## **The Proposed Dry Wash Reservoir: Size and Shape**

Prepared by Wayne D Pennington  
for the Ivins City Council meeting of March 21, 2024

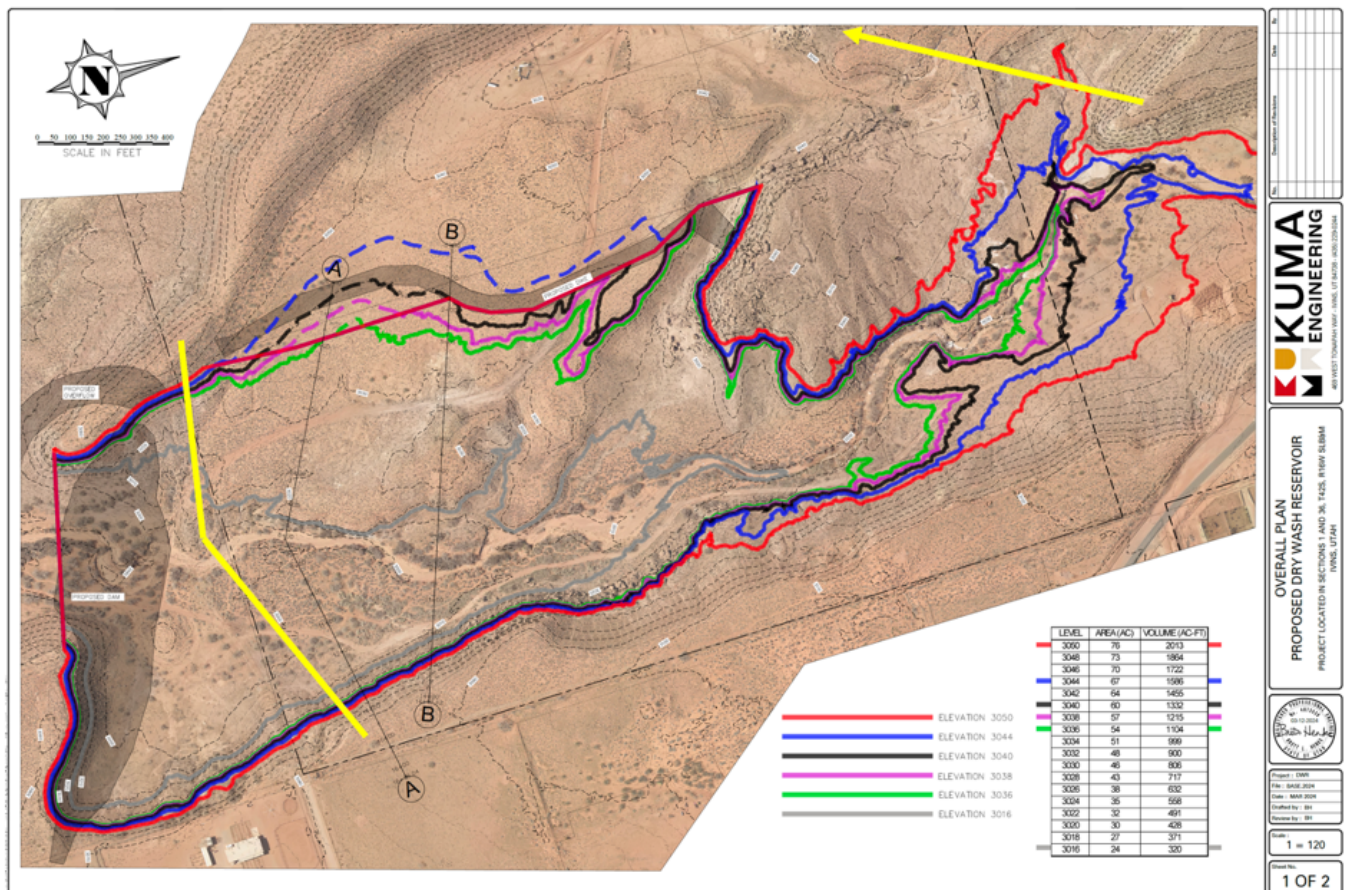
The Geotech Study clearly identified 3,040 ft elevation (black line in Figure1) as the maximum height for a reservoir with a dam at this Dry Wash location, saying (p.17) “it is our opinion that the **high water level should not extend above elevation 3040 feet.**” It also states (p. iv) “Efficient storage with a dam at this location is **limited to about 1300 acre feet due to the competent bedrock elevation.**” In Chapter 5 (p.21), the Geotech Study emphasizes: “it is our opinion that the high water level **should not extend above elevation 3040 feet. This results in a maximum storage capacity of about 1300 acre feet...**” This conclusion is based on the poor quality of rock (soil) above 3,040 ft in the formations

The EA also specified **a high-water level of 3,040 ft**. Additionally, the EA calculated a **capacity of 1335 acre-ft** of water, and an inundated **surface area of 63 acres** (p. 11 Appendix C). These values are all internally consistent, and verified to be consistent by modern mapping methods (see the table inserted in Figure 1 for confirmation).

The 2004 Geotech Study considered a number of locations for the dam site. The only location that would yield a capacity greater than 1335 acre-ft is further upstream, together with a large dike, as shown by the yellow lines in Figure 1. This configuration was implicitly rejected by the EA, which considered and specified a dam at the location shown by shading in Figure 1. [Any claims that the EA or other environmental studies allowed a larger reservoir are apparently conflating the studies done for alternate, upstream, dam locations with the one that was finally accepted by the EA.]

For the WCWCD-proposed high-water level reservoir at 3,044 ft, the area exposed to drying out is 43 acres. [The difference between this value and my earlier figure of 47 acres is the area excluded by the presence of the dike in the current assumption.] The area exposed at low-water level by a reservoir with 3,040 ft high-water level covers a surface area of 36 acres; incrementally lower high-water levels progressively decrease the size of the exposed area. We should note that the WCWCD is planning to excavate some of the basin (reservoir bottom) to help increase capacity and to provide material for construction of the dam and dike; if additional material can be excavated and strategically placed along the shoreline, capacity can be increased while decreasing the surface area, a desirable consequence from all points of view, and one that the WCWCD has expressed interest in.

Figure 2: Two cross-sections A-A and B-B identified on the map in Figure 1 by faint lines crossing the reservoir. Note the broad, shallow western flank of the reservoir, and the modest reduction in area submerged as high-water level is decreased. Vertical exaggeration is 2:1.

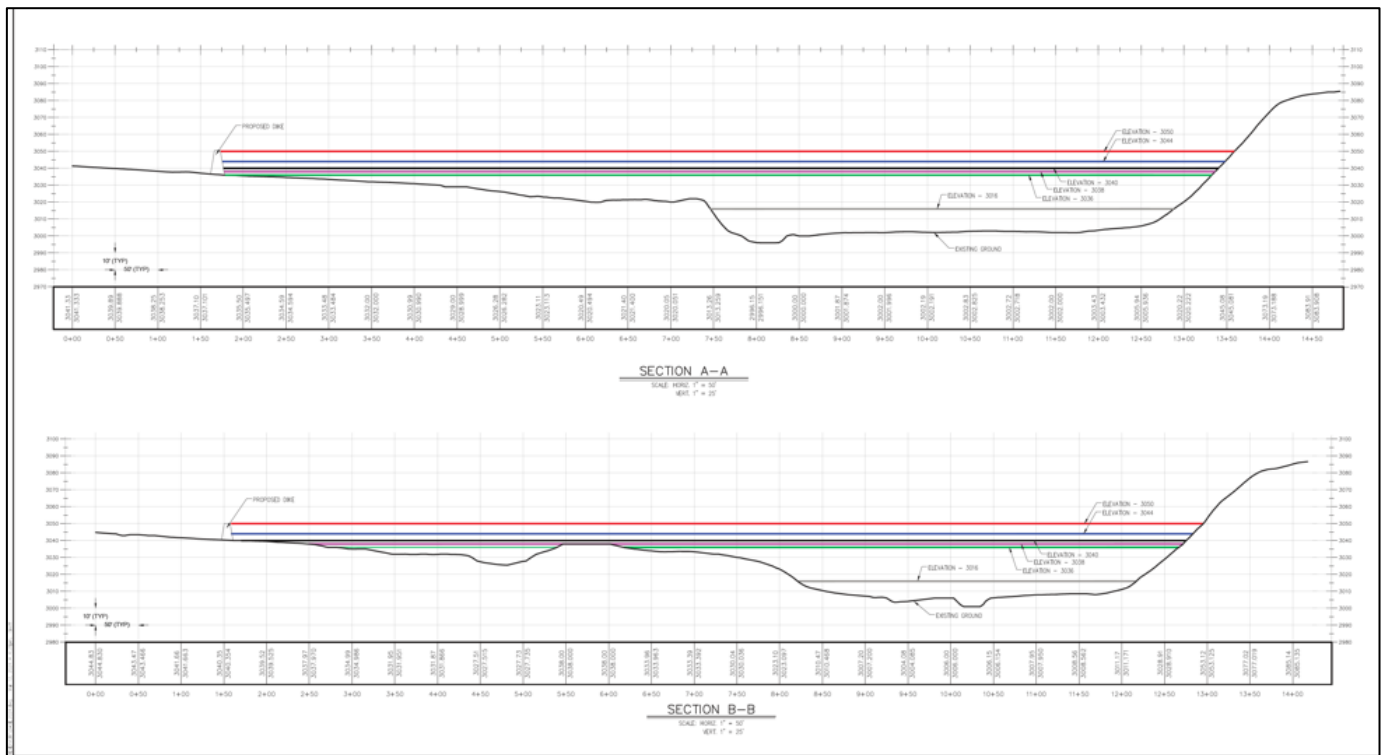
The problem of subaerial exposure is concentrated on the western side of the reservoir, as can be seen in Figure 1 and in the cross-sections shown in Figure 2.

What this means is that the smaller alternately exposed areas near the upstream end of the reservoir will not result in much airborne dust, due to their shorter lengths and enclosure by steeper walls. But the broad, shallow flank on the western side of the reservoir will, for nearly any wind direction, present a hazard due to windborne particles if the fetch is long enough. One of our objectives in reservoir design should be to minimize the fetch, the distance along which wind can produce saltation and pick up material.

This reduction in alternately exposed and submerged areas, or length of fetch, can be accomplished in a few ways, but the most beneficial for Dry Wash would be to move the dike further toward the center of the reservoir, while reducing the high-water level to some lower level, in the meantime excavating the material from the western floor of the reservoir and placing it landward of the dike. [This was the basis for my earlier proposal for a high-water level of 3,038 ft, leading to a capacity of 1215 acre-ft before excavation; this would help, but not completely mitigate the issue.]
